UNITED STATES PATENT AND TRADEMARK OFFICE

APPLICATION NO.	FILING DATE	FIRST NAMED INVENTOR	ATTORNEY DOCKET NO.	CONFIRMATION NO.
09/853,276	05/11/2001	Randall D. Blanchard	LITD:0013	5871

Office Action Summary

DETAILED ACTION

Fig. 1

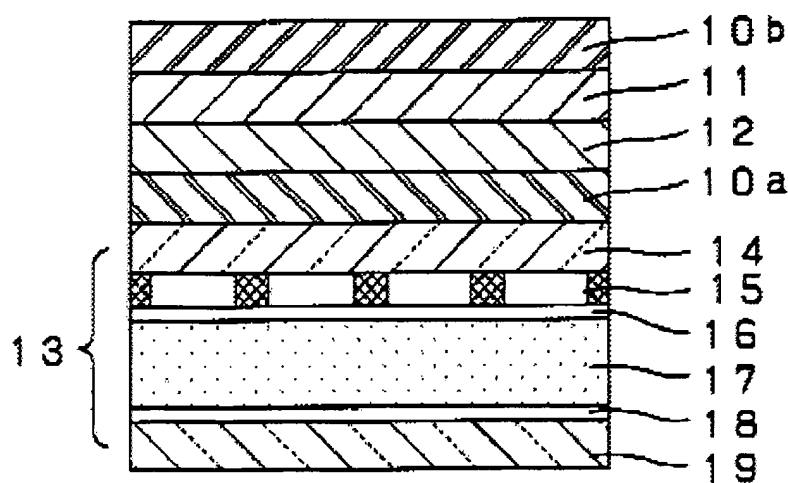
As to claims 1, 2, 5, and 15, Hatanaka discloses in Embodiment 2 (col. 7, line 35 through col. 8, line 20) and Figures 1-3, a liquid crystal display (LCD) comprising:
a liquid crystal cell display screen, 13;

a polarizer, 11 (Applicant's transparent panel), having a backside and an anti-glare front surface configured to diffuse ambient light comprising an anti-reflective layer disposed on the anti-glare front surface (col. 8, lines 1-6); and

a front scattering film layer, 10a (Applicant's bulk diffuser), wherein the bulk diffuser comprises a diffusive material configured to diffuse light within the diffusive material (col. 7, lines 49-67), disposed between the display screen, 13, and the backside, wherein the bulk diffuser is bonded (col. 7, lines 65-67 and col. 8, lines 3-7) to the display screen and the transparent panel, and

the bulk diffuser is configured to diffuse image light of the display (col. 7, lines 49-67).
